Technical Bulletin

55 07 05 July 11, 2007 2015354

Hood Lock Release Handle Support Bracket Broken

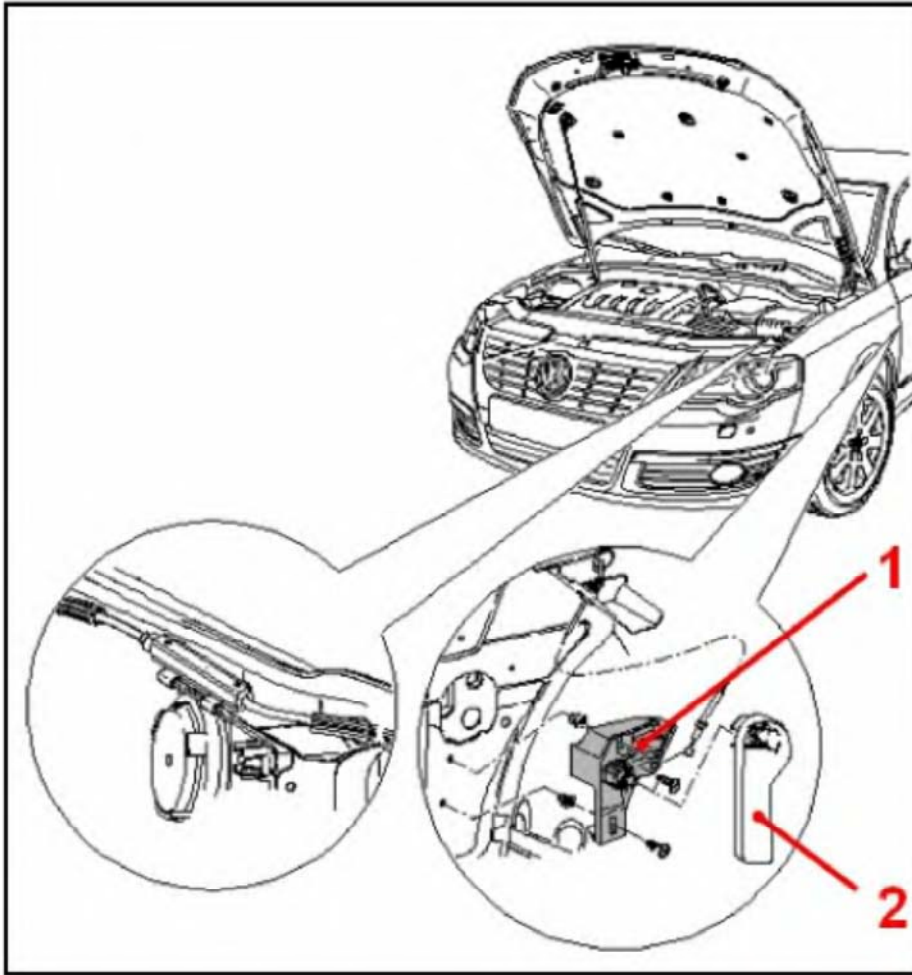
The support bracket of the handle for releasing hood lock is broken.

Insufficient material strength of support bracket for hood lock handle.

Improved material properties of support bracket for hood lock handle.

- Beginning with VIN : 3C_7E230195
- Beginning with VIN: 3C_7P155675

- Raise and support hood.
- Remove hood lock handle from hood lock, see Repair Manual Group 55 Hood, Lid in ElsaWeb..
- Separate hood release cable from hood lock, see Repair Manual Group 55 Hood, Lid in ElsaWeb..
- Remove hood lock (2), see Repair Manual Group 55 Hood, Lid in ElsaWeb.

- Install hood lock assembly (2), see Repair Manual Group 55 Hood, Lid in ElsaWeb.
- Adjust hood lock assembly (2), see Repair Manual Group 55 Hood, Lid in ElsaWeb.
